ADDENDUM NO. 2

Project Name: Post Hurricane Ian County Park Dune Repairs

Bid Number: 2023014

Turtle Trail Access
- 100 linear feet

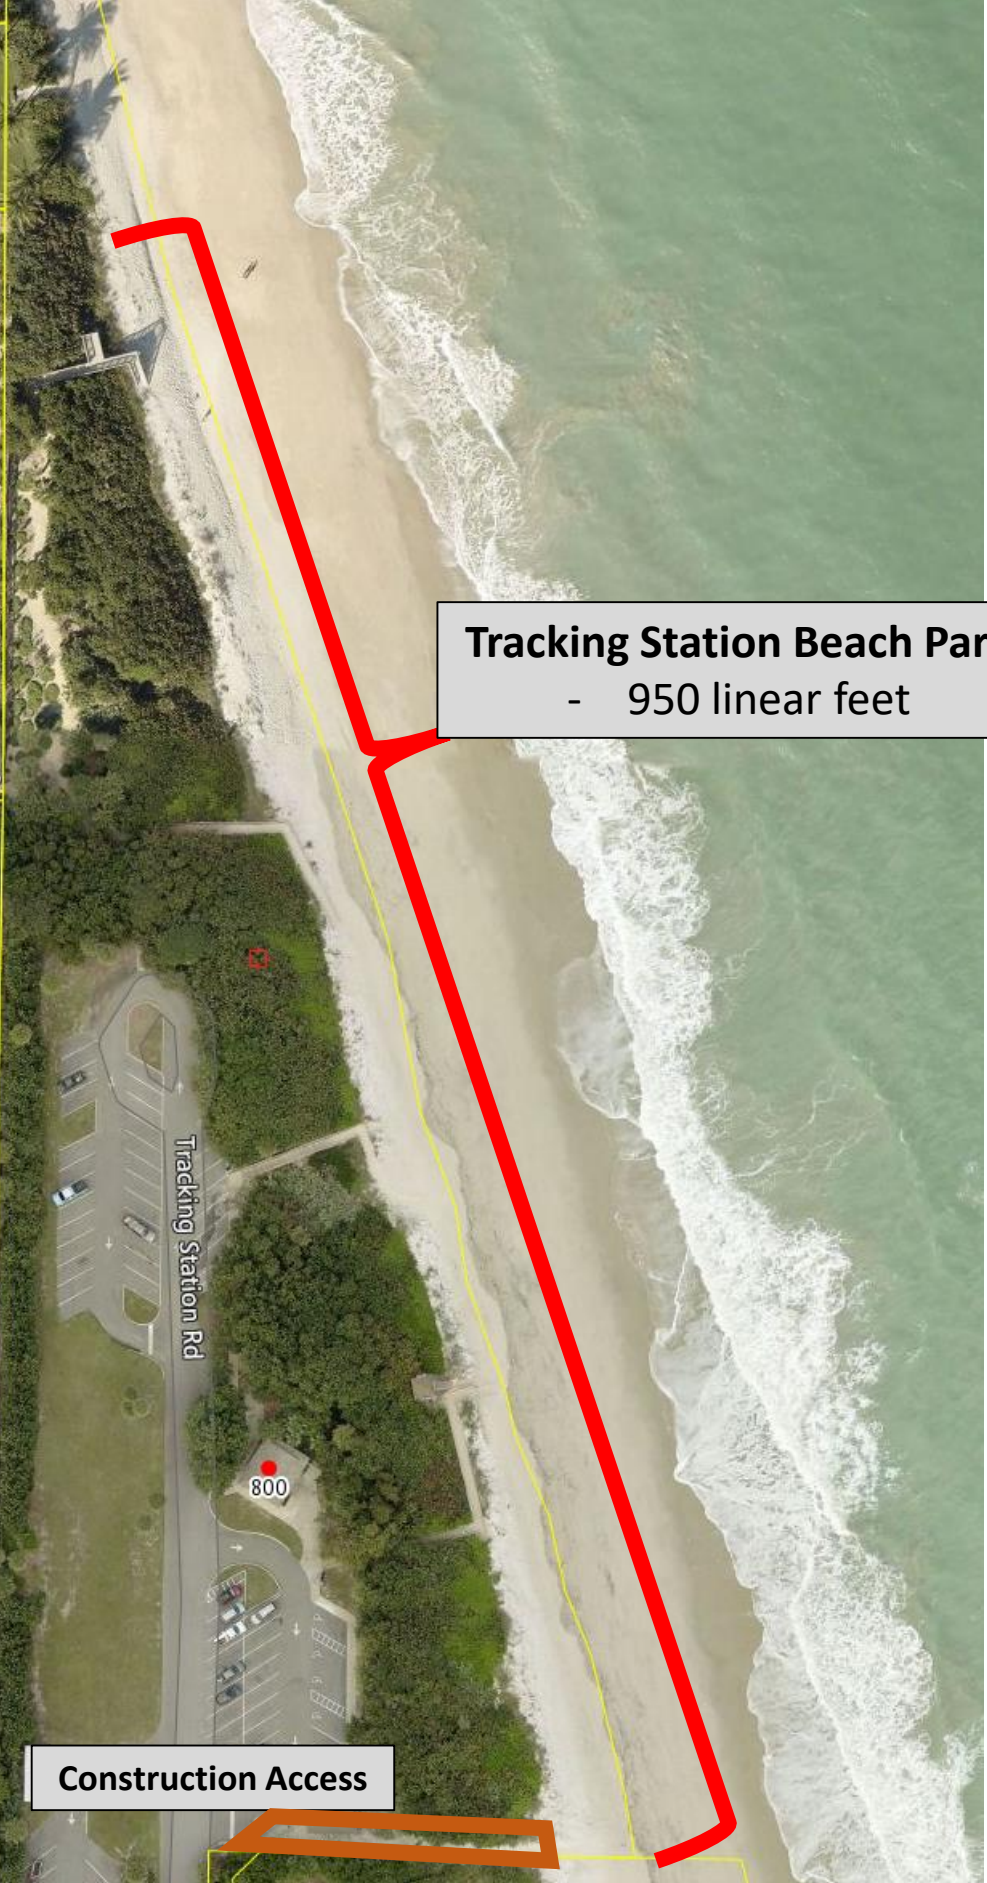
Question 2: Can the County provide an aerial view of the 5 proposed work areas. This information is essential as it depicts where the actual repair work is to be performed. Without this information the contractor is just taking a guess of where the work area actually is.

Answer 2: Included with this addendum response are the aerial images of anticipated sand placement activities within the County's specified beach access parks.
